ADDENDUM

Supply and E&C of Side Beam for WT-4&5

Tender Ref: 77/21/6072/DSP

1 x 700MW BTPS-3, WT-4 & WT- 5 NEW BEAM SUPPLY AND ERECTION

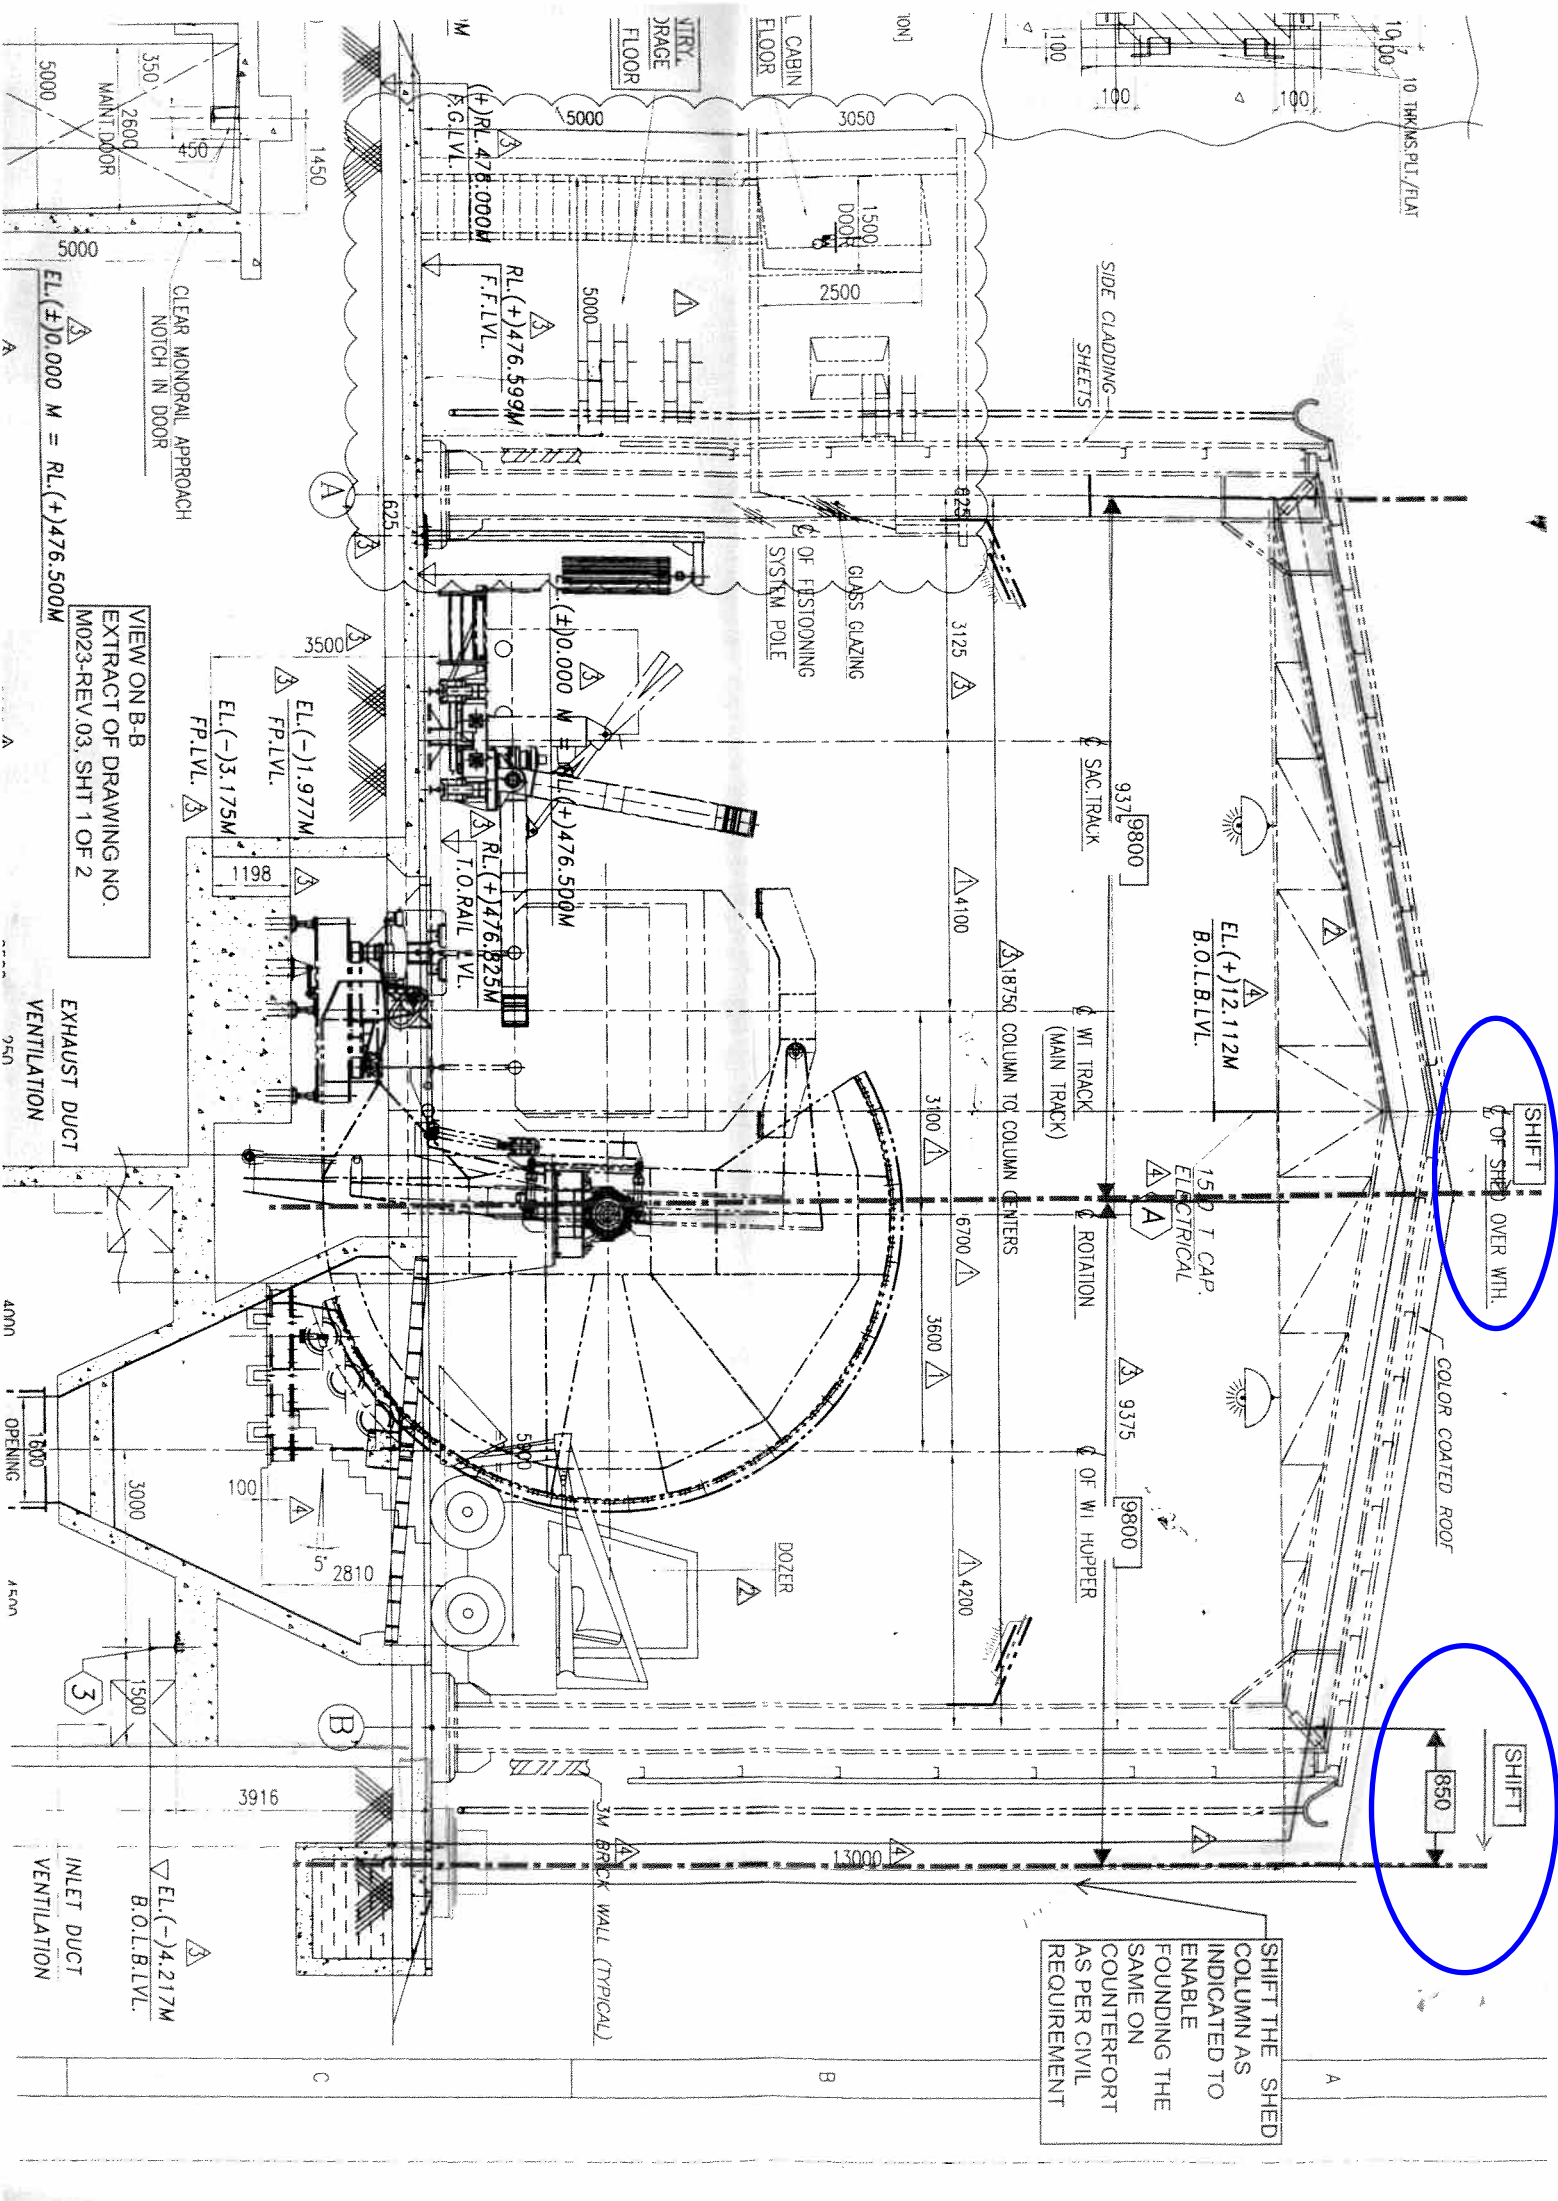
SHIFT THE SHED
COLUMN AS
INDICATED TO
ENABLE
FOUNDING THE
SAME ON
COUNTERFORT
AS PER CIVIL
REQUIREMENT
